Re: Scholls Valley Heights; Phases 4 – 7 Design Review; CWS file 17-001934 (Tax map 2S10600 Tax lot 00301, 00302)

SCHOLLS VALLEY HEIGHTS - PHASES 4, 5, 6 & 7
 CITY OF BEAVERTON, OREGON

Project: Scholls Valley Heights Phase 4-7 Design Review
PDG No. 386-002

Service Provider Letter

FS1 PLAN

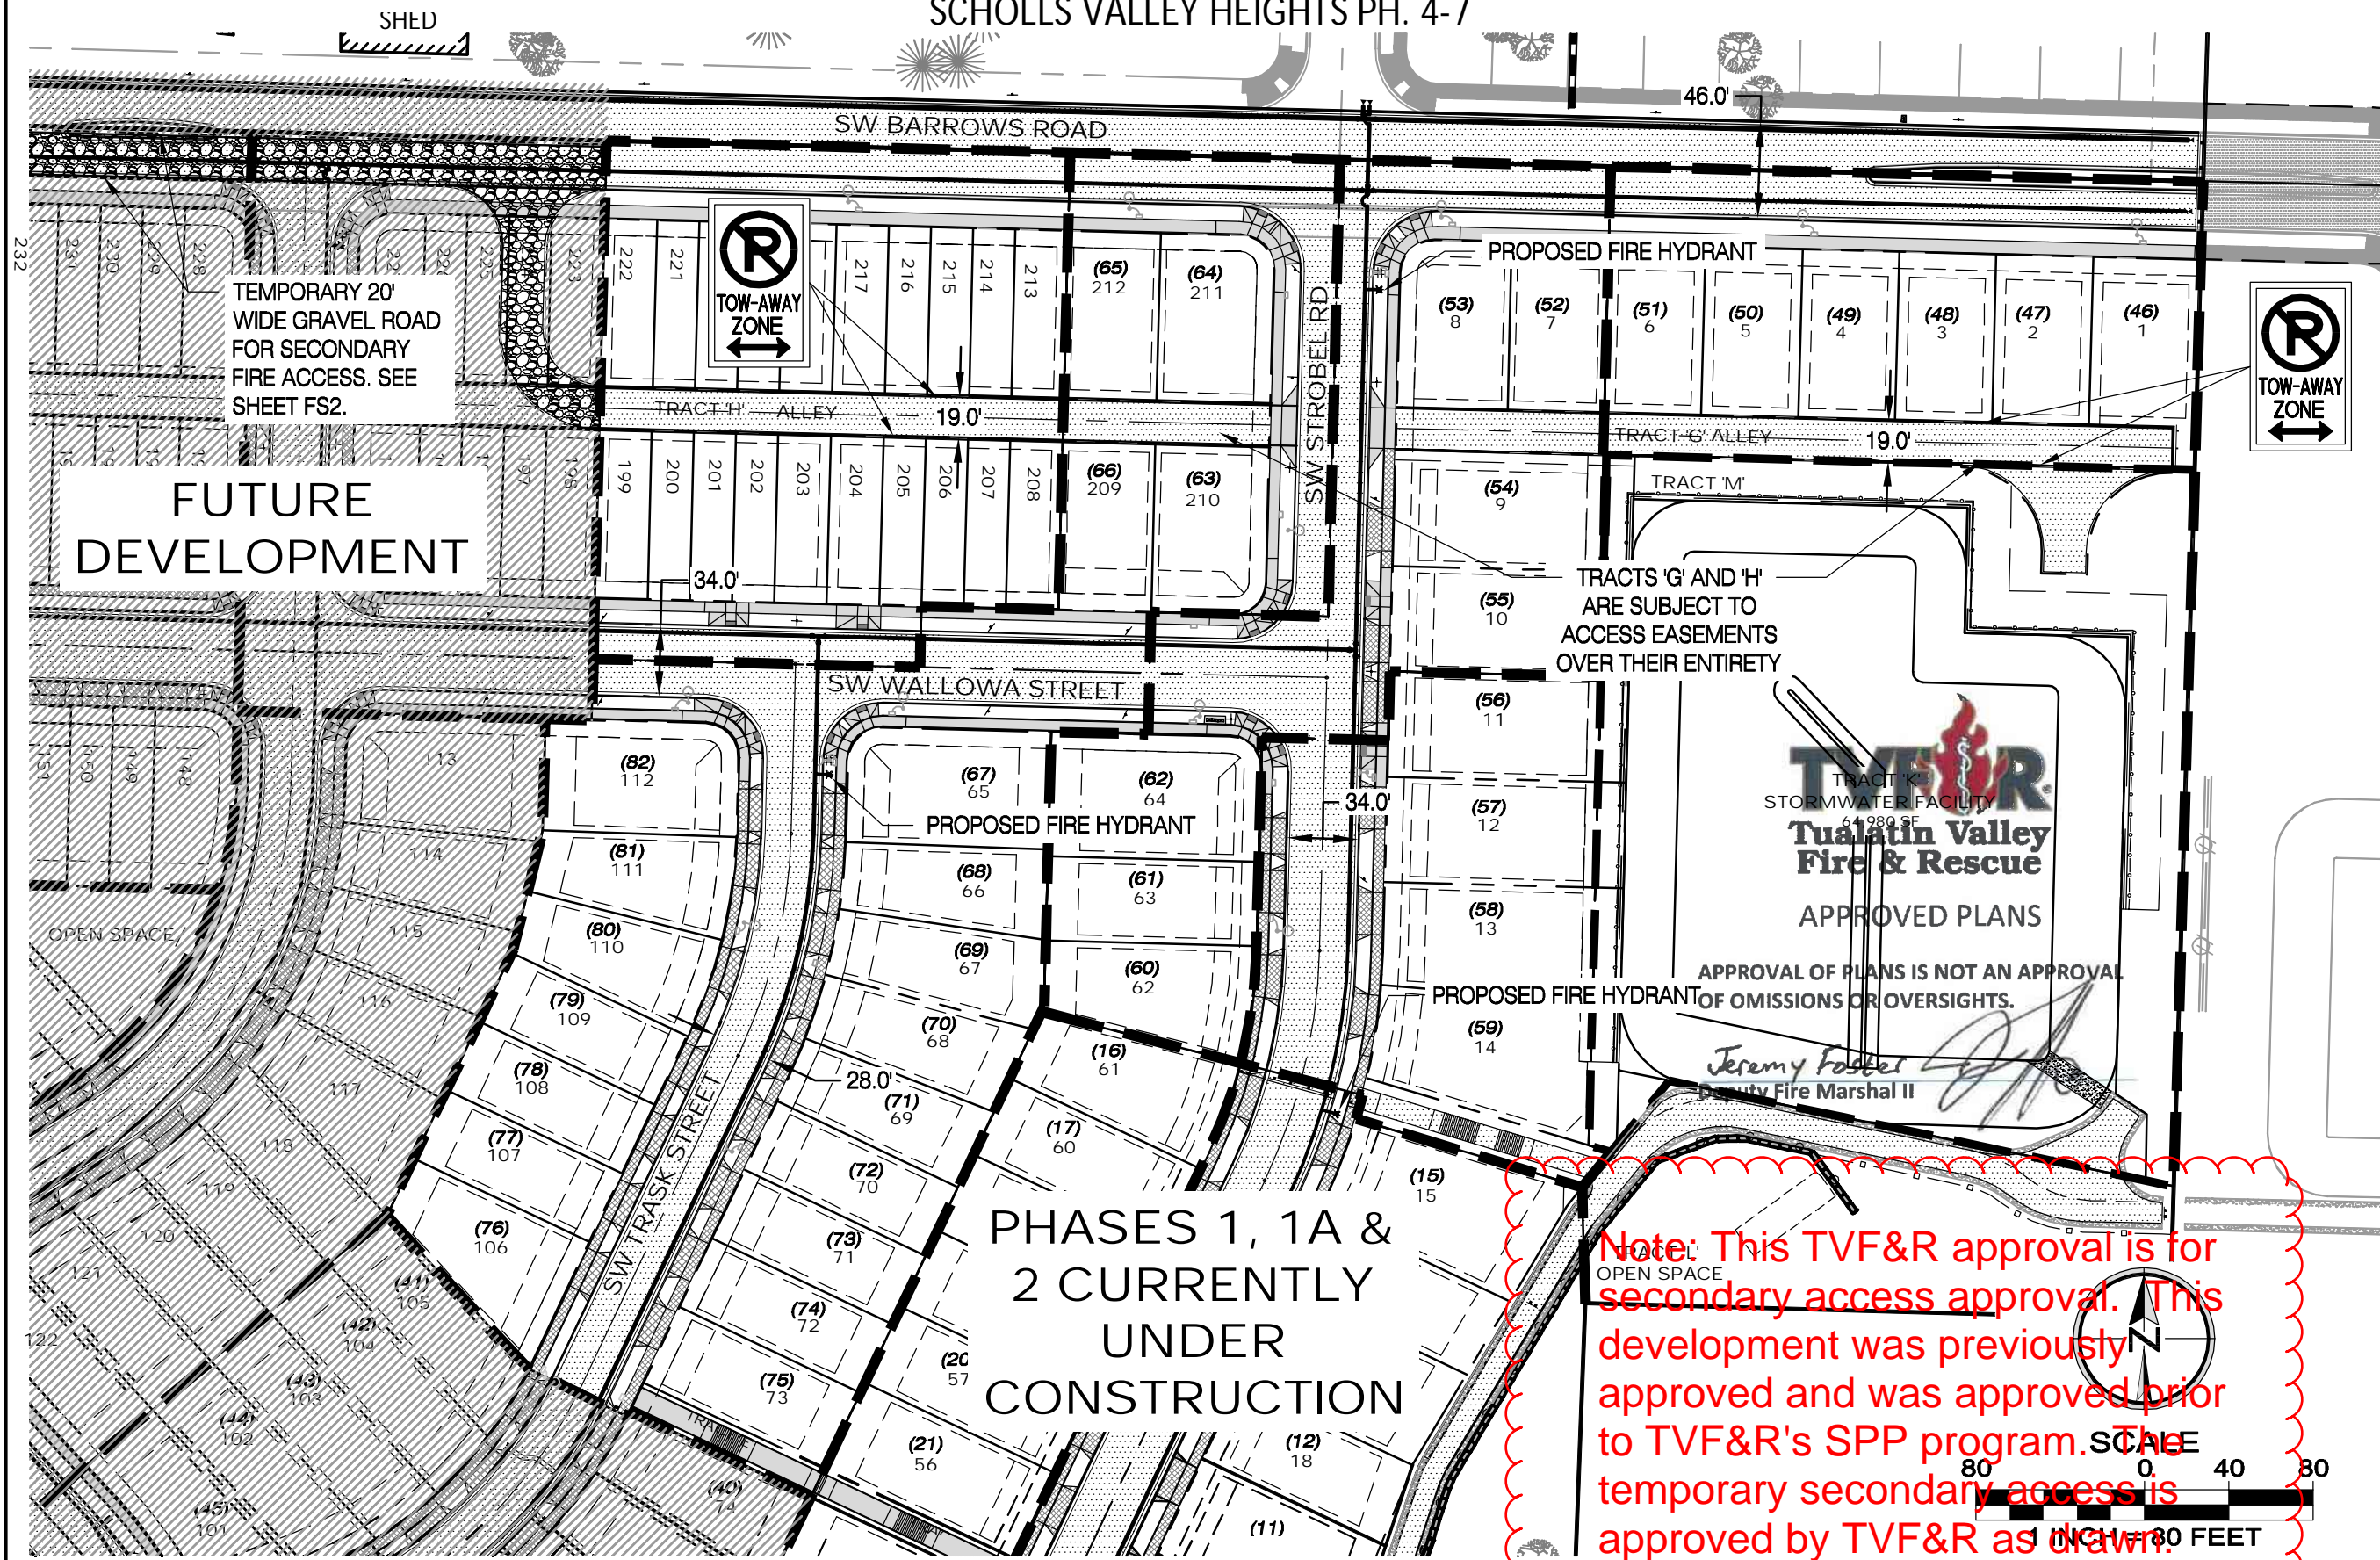
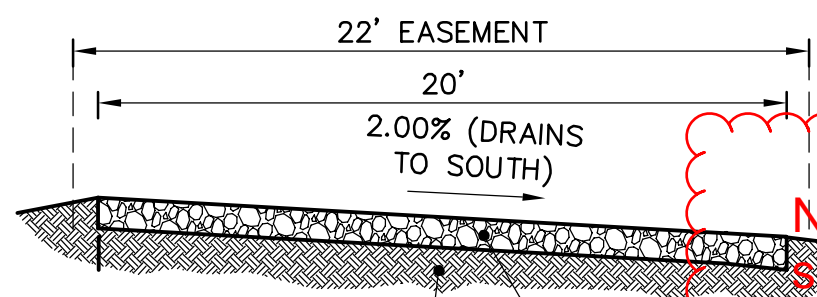
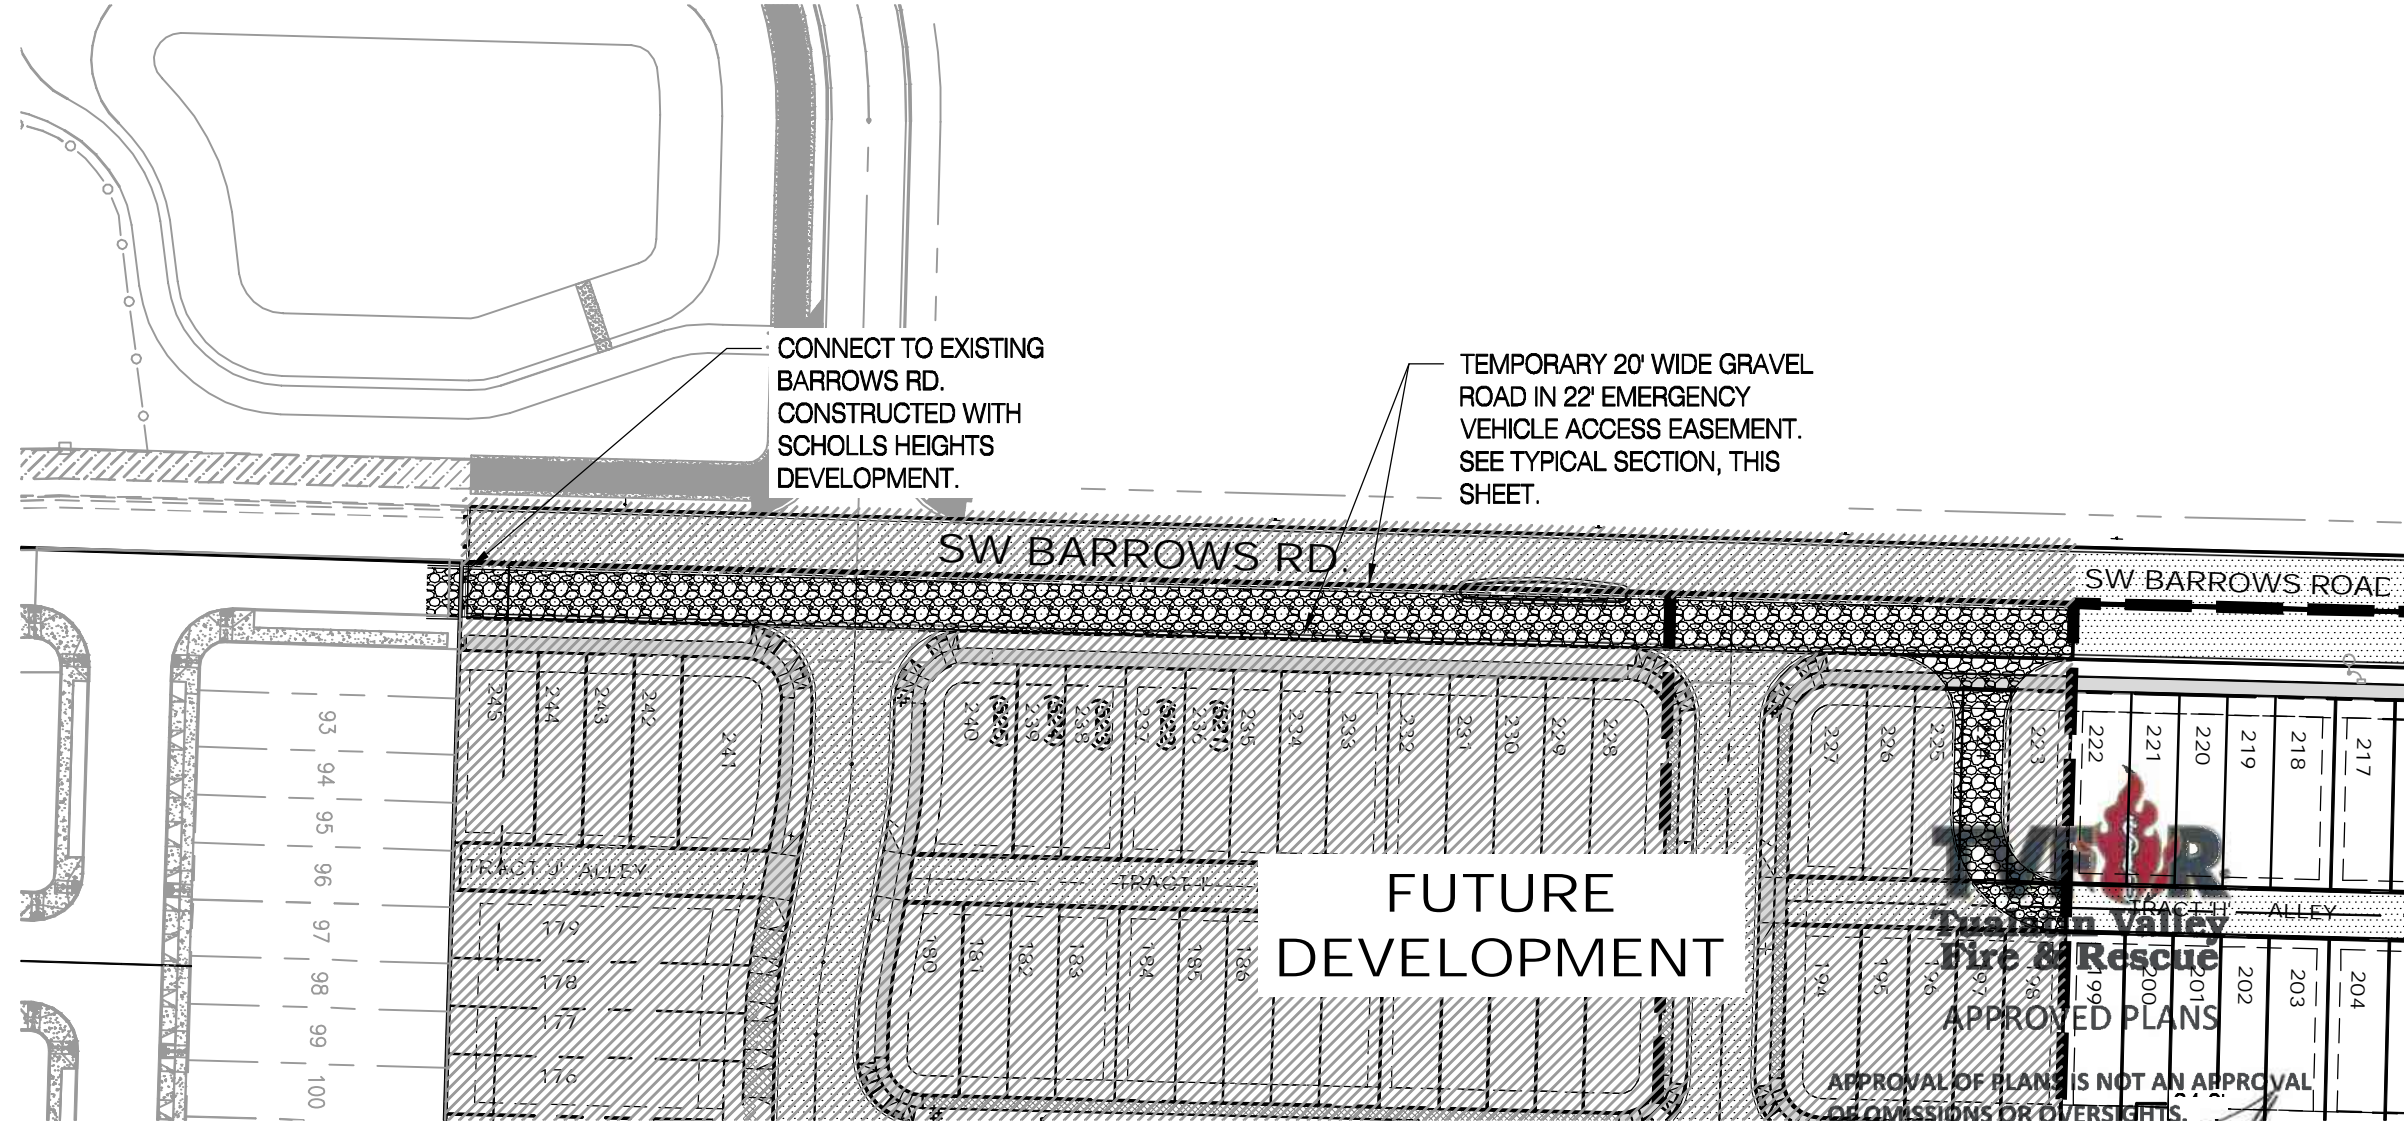
Note: This TVF&R approval is for secondary access approval. This development was previously approved and was approved prior to TVF&R's SPP program. The temporary secondary access is approved by TVF&R as drawn.
Revision Date 3/27/2022
